RE: NRC Docket 40-06563, NRC License STB - 401

Mallinckrodt's responses to certain NRC staff requests for information concerning the Draft C-T Phase II Decommissioning Plan (CT Phase II DP) are enclosed. These responses are a follow-up to discussions between Mallinckrodt and NRC staff on January 24, 2006. This meeting was summarized in the NRC report, dated February 16, 2006, and these responses relate specifically to Actions 2, 4, and 5. Enclosed are five copies of the following:

## Clarification of Response to Certain NRC Requests for Additional Information about the C-T Phase II Decommissioning Plan

Figure 43A. Cumulative Distribution of Indoor and Outdoor Shielding Fraction

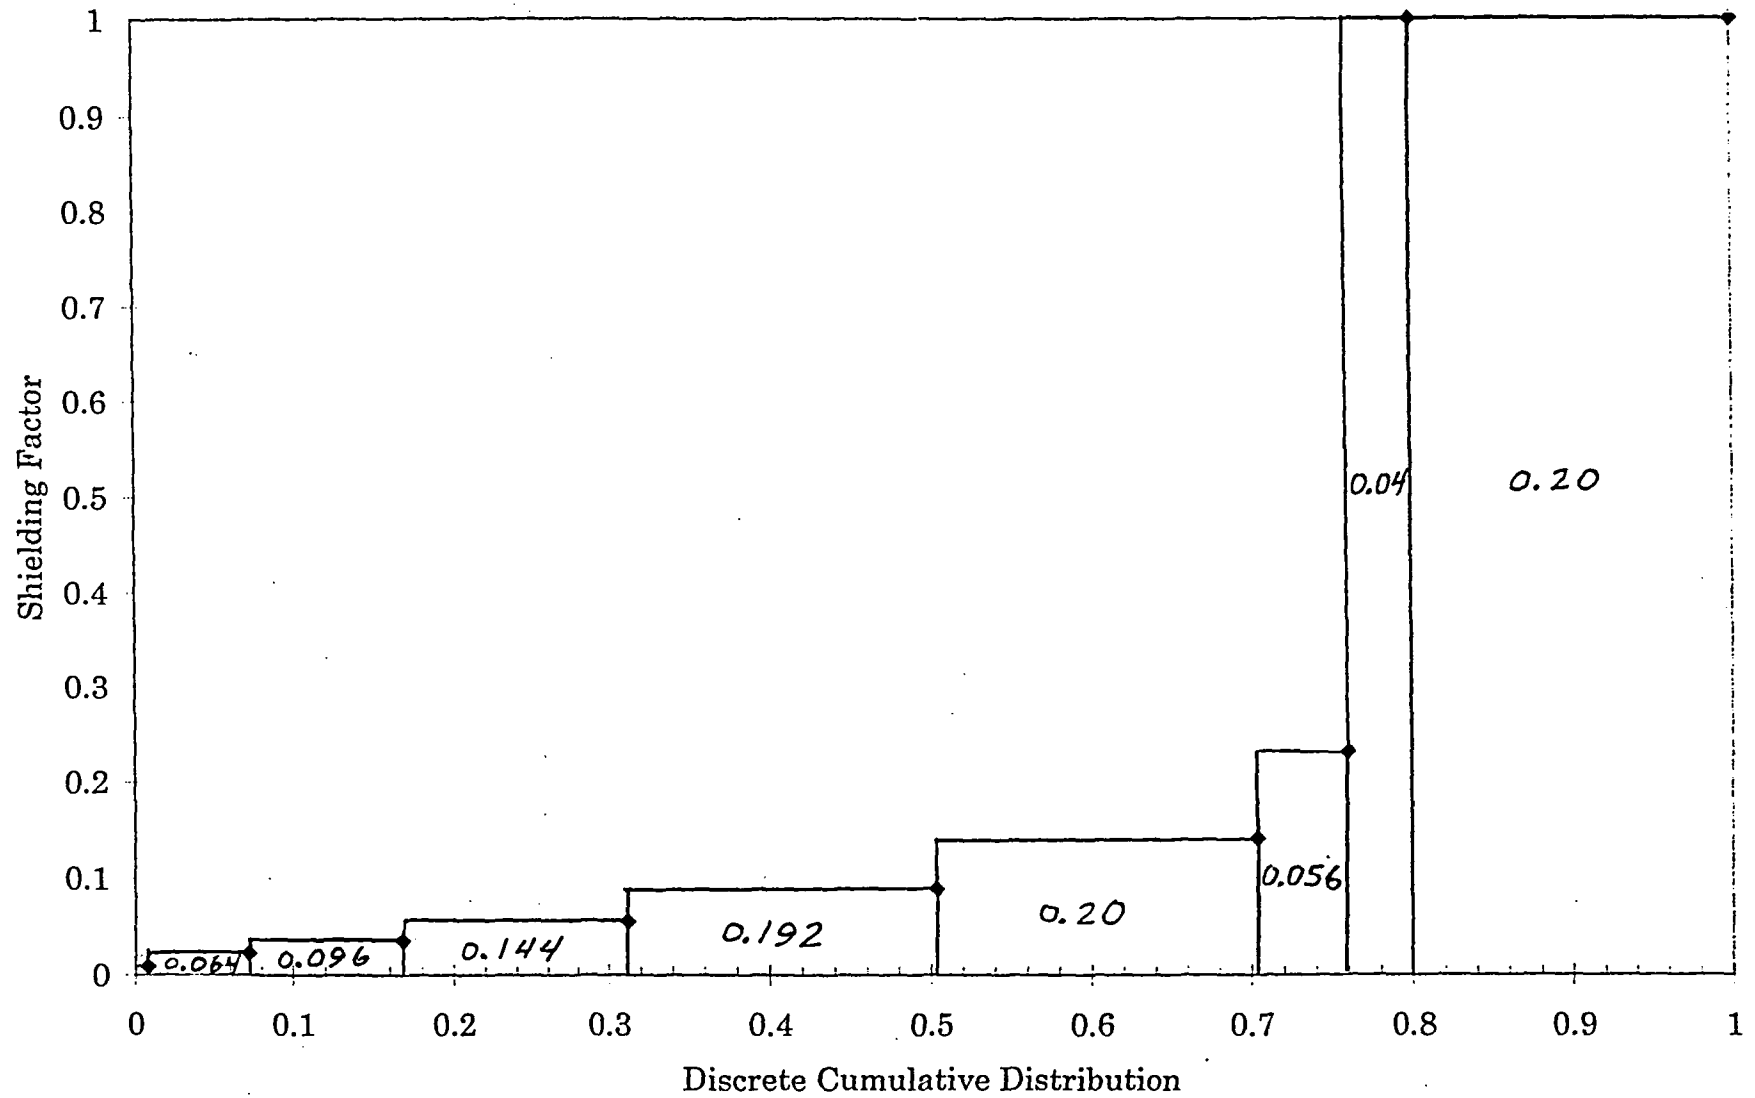
(c) The licensee selected an indoor gamma shielding factor of 0.17. In other words the licensee assumed that only 17% of outdoor gamma radiation can be penetrated indoors. The RESRAD default value is 0.7. The licensee indicated that Plant 5 has concrete slab floors or concrete walls with few windows. Therefore, the licensee assumed that the factor 0.17

DCGL have been revised to include the effect of probabilistic distribution of indoor gamma shielding factor.

An analysis of the effect of radiation attenuation by a building, especially floor thickness, on radiological dose for the portion of time a worker spends indoors during industrial occupation has been performed. Occupancy 20% of the time on bare ground, with gamma shielding factor = 1.0, is, in addition, assumed to apply deterministically while out-of-doors, even though most of Plant 5 is paved. Overall, then, dose modeling has been adjusted to simulate a person on bare ground about 24% of their time while on-site and thin shielding an additional 5.6% of the time. This is illustrated diagrammatically in Figure 43 A. (same as CT 2 DP Appendix C, Attachment A, Figure C3.)

The gamma shielding factor indoors has been revised to treat it probabilistically and to assume a fractional occurrence on bare ground and a thin floor. Table 43-1 (same as CT 2DP Table 5-2) describes the discrete cumulative probability distribution simulating the external gamma shielding factor that is applicable indoors.

**Figure 48 Refinement of CT 2 DP §5 Model for Pavement**

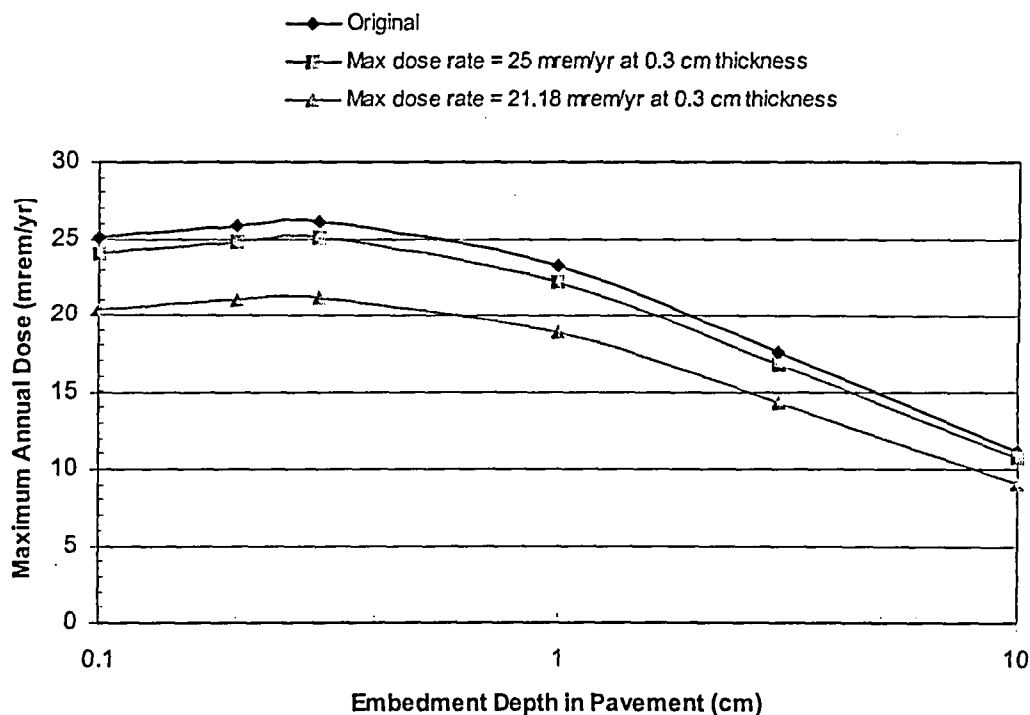
(h) Assumptions for the Industrial Worker Exposure to Pavement: For the exposure of industrial worker to residual radioactivity on pavements, the licensee made similar assumptions as those for the soil. However, the licensee assumed a thin layer of surface contamination on pavement with thickness of 0.1 cm. The licensee modified the approach to convert volumetric dose analysis results into surface activity results (e.g., dpm/100 cm<sup>2</sup>). This was done through derivation of the radionuclide volumetric dose factor (mrem/y per pCi/g), converting this factor into areal density factor pCi/100 cm<sup>2</sup> (e.g., by assuming a thickness of pavement of 0.1 cm and a density of 1.5 g/cm<sup>3</sup>) corresponding to 25 mrem/y and then converting the pCi into dpm (e.g., by multiplying by 2.22). Therefore, considering the volumetric dose analysis approach the following parameters and assumptions were made for industrial worker exposure to the pavement source: (i) Contaminated Zone: the

A premise of CT 2 DP, §5, Table 5-3 is that an equivalent areal density of CT residue would produce less dose when embedded than when accumulated on the surface; hence the source was originally modeled as concentrated into a 0.1 cm layer on the surface. Unexpectedly, maximum total dose occurs when the source is 0.2 to 0.3 cm thick, or deep, as illustrated in Figure 48, curve “♦ Original.”

This observation prompted derivation of  $DCGL_W$  assuming 0.3 cm contaminant thickness of the long-lived radionuclides in the uranium series, the actinium ( $U^{235}$ ) series, and the thorium series, assuming short-lived nuclides (<180 day half-life) to be in transient radioactive equilibrium with their parent. The revised result appears here in Table 48-1. The result of this refinement is illustrated in Figure 48 by the curve, "■ Max. Dose Rate = 25 mrem/yr at 0.3 cm thickness". Thus, if contamination were on the surface or even if it were unevenly embedded into pavement or a building slab, controlling to a maximum areal density specified in Table 48-1 would assure that maximum annual dose would not exceed 25 mrem/yr.

Figure 48, curve “▲ Max dose rate = 21.18 mrem/yr at 0.3 cm thickness,” confirms that the revised DCGL<sub>w</sub> in Table 48-2, to become CT 2 DP §5, Table 5-4 (replacing Table 5-3),<sup>11</sup> would constrain maximum potential annual dose from contamination on pavement, even if embedded, to no more than 21.2 mrem/yr.
